ADDENDUM 1

DATE: 01/30/18
PROJECT: UCT Expansion Interior Buildout
RFP NO: RFP 744-R1805 – UCT Expansion Interior Buildout
OWNER: The University of Texas Health Science Center at Houston
TO: Prospective Proposers

A1 STAIR SECTION
SCALE: 3/8" = 1'-0"

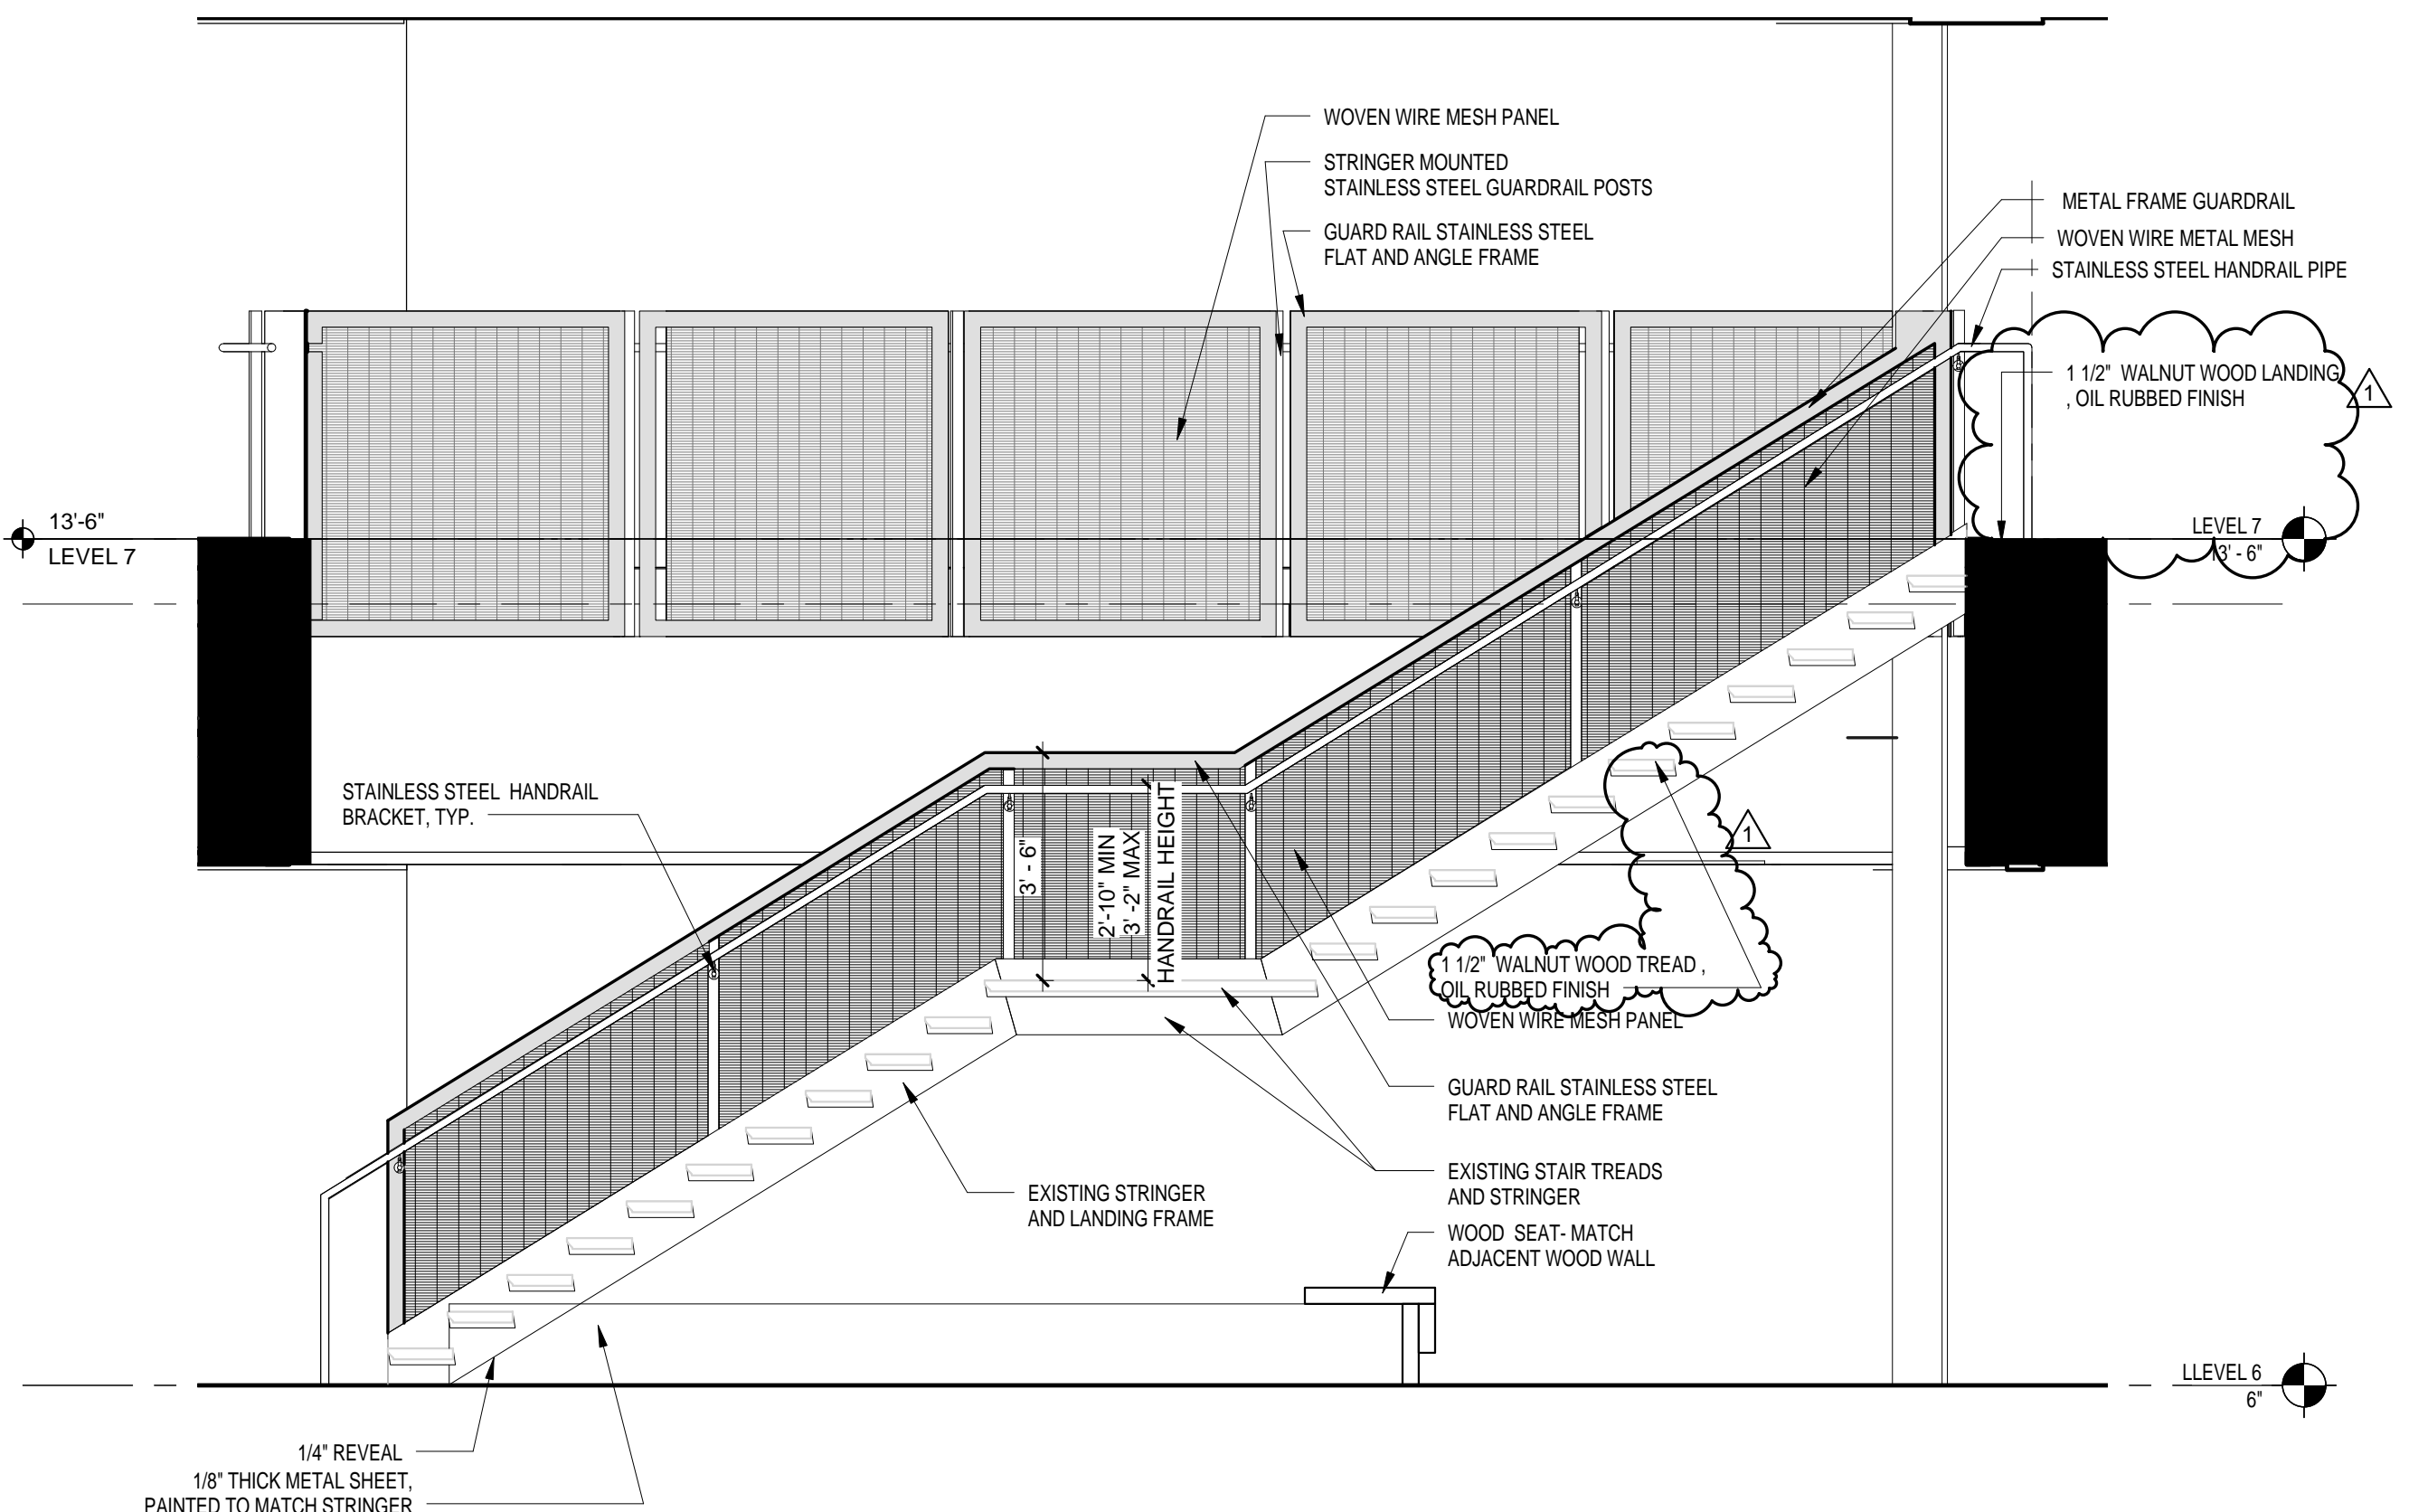
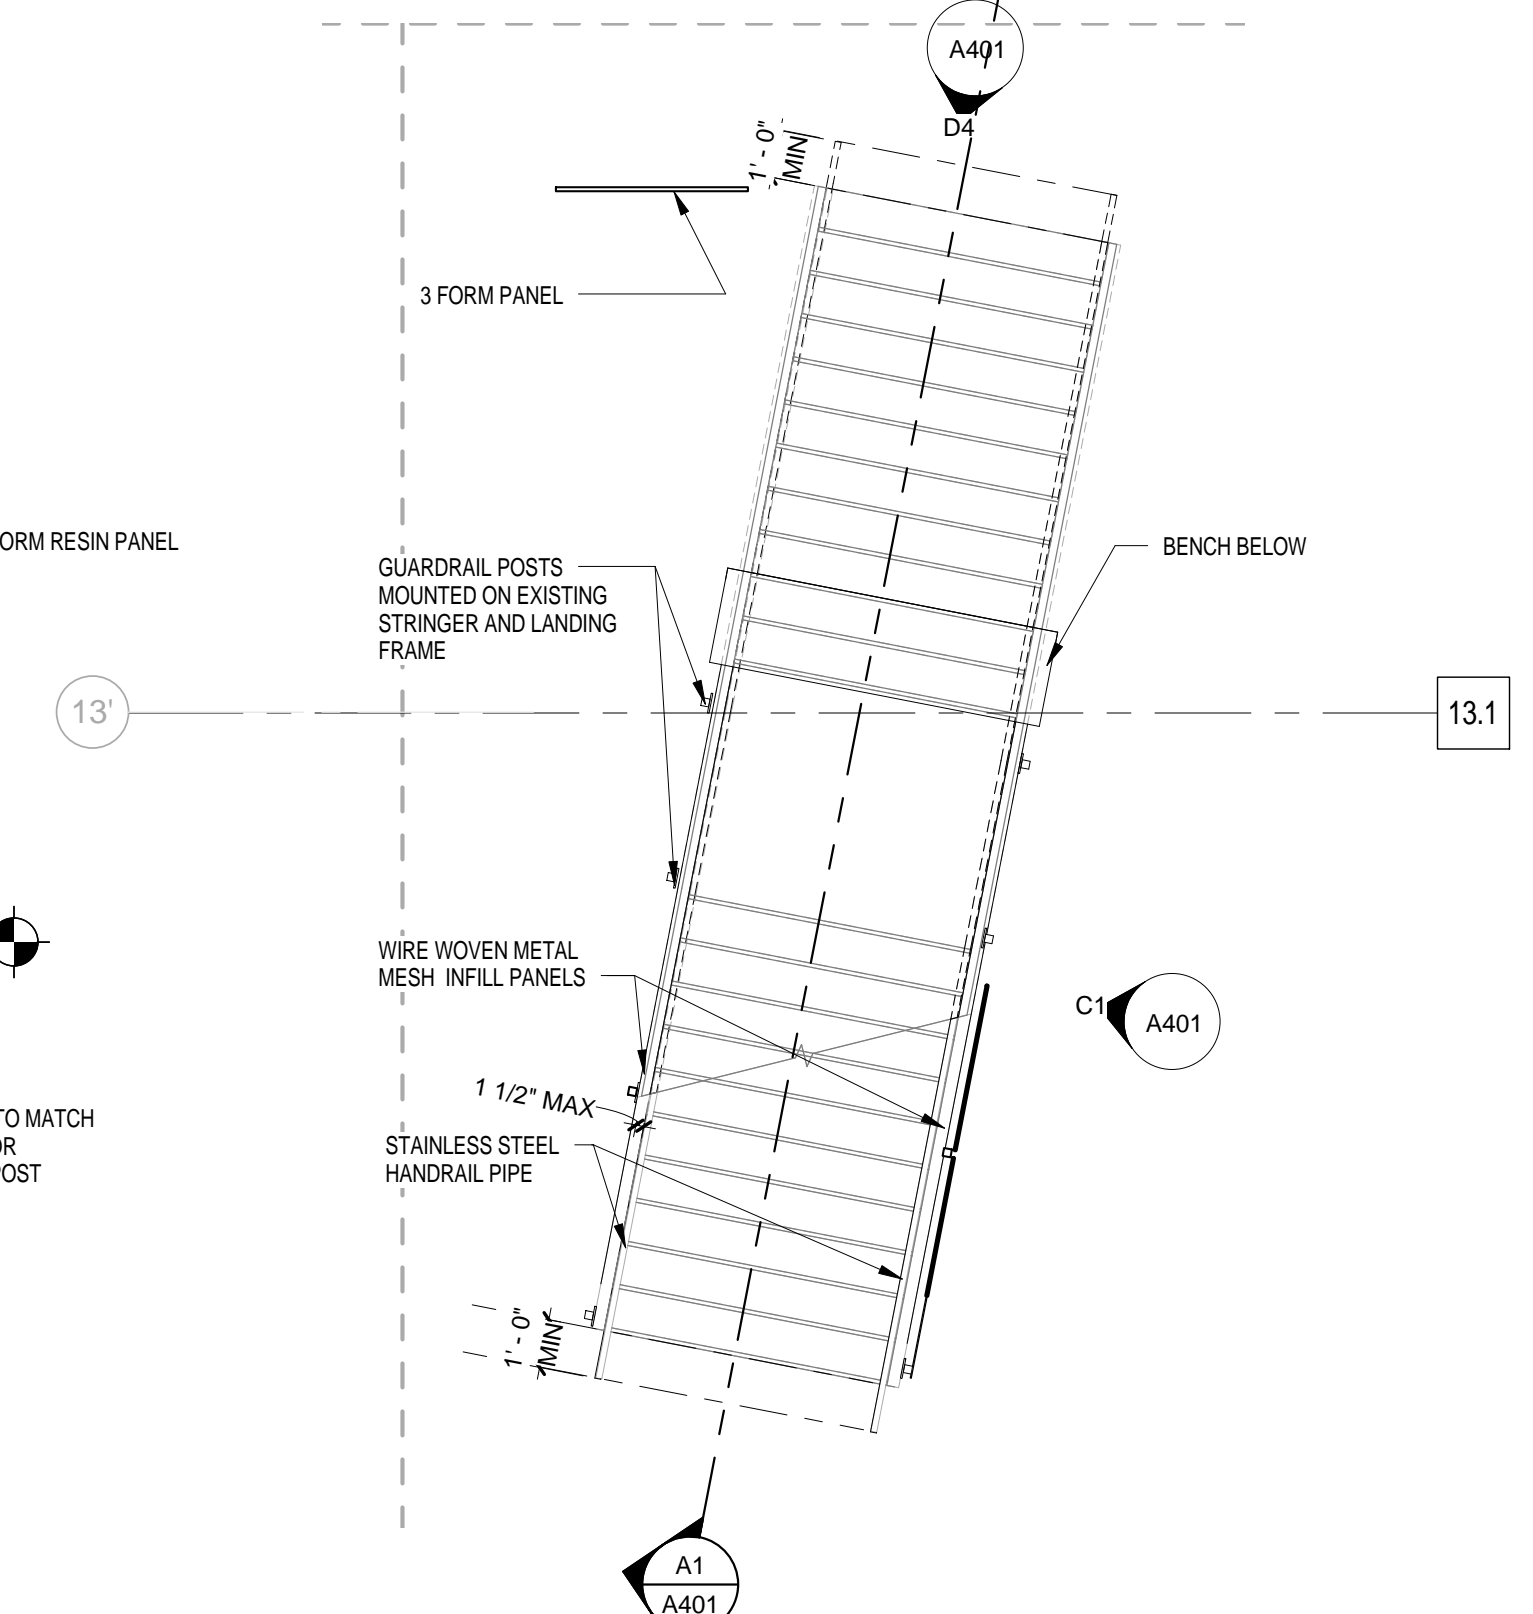
31. Sheet A401 – Please provide the following clarifications:

a. Detail C1 – Please provide detail for Guard Rail Stainless Steel “Flat and Angle Frame”

b. Detail C3 – Please clarify how mesh support tubes are mounted to the stringers.

c. Detail C3 – Detail indicates stainless steel fascia. Please clarify if this fascia is existing or part of this project installation. If part of this project, please provide details and location of stainless steel fascia.

d. Please clarify handrail. Details A1 & C1 indicate a single line rail, while A3 & D1 indicate a 4-line rail.

32. Sheet A401 – Detail C5 indicates wood flooring to match existing stair treads. Please provide wood floor material selection and specifications.

a. Is the extent of the wood flooring to be the hatched square shown in this detail only?

Provided

Vertical Support tubes to be mounted on stair stringer see drawing for notes

Stringer part of the core and shell project. No Steel Fascia to be used.

Single line handrail is to be provided

All details to be provided in Addendum 1 documents

Flooring and treads will be added into the interior Buildout set in an Addendum.
1 1/2" WALNUT WOOD TREAD
